Access Compliance Report

Public Rights-of-Way

Intersection ID: 46223	Main Street: COBLE_AV	Cross Street: PARKERS_CROSSING_DR	Location: SW
ADA ID: 29EC57FCC168	Ramp Type: PerpDiag	Initial Pass/Fail: Fail	Overall Compliance: No
		Severity Score: 22.5

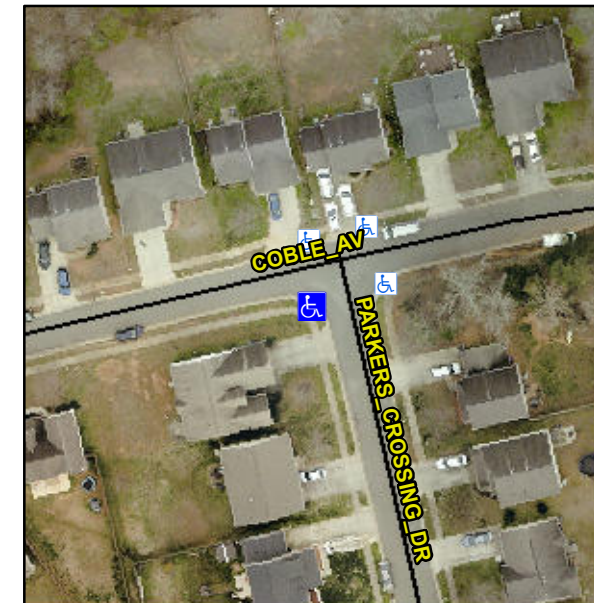
Not Found, R304.5.1, R304.2.2, R304.5.3

Compliance	Description	Data	Compliance	Description	Data
N/A	Ramp Length (in)	48.0	No	Ramp Slope (%)	9.2
No	Ramp Width (in)	38.5	No	Ramp XSlope (%)	2.5
N/A	Flare Type LT	N/A	N/A	Flare Type RT	N/A
N/A	Flare Slope LT (%)	N/A	N/A	Flare Slope RT (%)	N/A
N/A	Flare Traversable LT?	N/A	N/A	Flare Traversable RT?	N/A
N/A	Landing Length (in)	N/A	N/A	DWS Provided?	N/A
N/A	Landing Width (in)	N/A	N/A	DWS Contrast?	N/A
N/A	Landing Slope (%)	N/A	N/A	DWS Length (in)	N/A
N/A	Landing X Slope (%)	N/A	N/A	DWS Full Width?	N/A
N/A	Landing Curb? (Y/N)	N/A	N/A	DWS Offset (in)	N/A
N/A	Shared Landing?	N/A			
N/A	Gutter Ponding?	N/A	N/A	Gutter Slope (%)	N/A
N/A	Gutter Lip Ht (in)	N/A	N/A	Gutter X Slope (%)	N/A
N/A	Painted X Walk1?	No	N/A	Painted X Walk2?	No
	X Walk 1 Direction	To E		X Walk 2 Direction	To N
N/A	X Walk 1 Width (in)	N/A	N/A	X Walk 2 Width (in)	N/A
	X Walk 1 Slope (%)	1.4		X Walk 2 Slope (%)	2.0
	X Walk 1 X Slope (%)	4.1		X Walk 2 X Slope (%)	1.6

Remove & Replace Curb Ramp With Two New Directional Ramps or Equivalent.
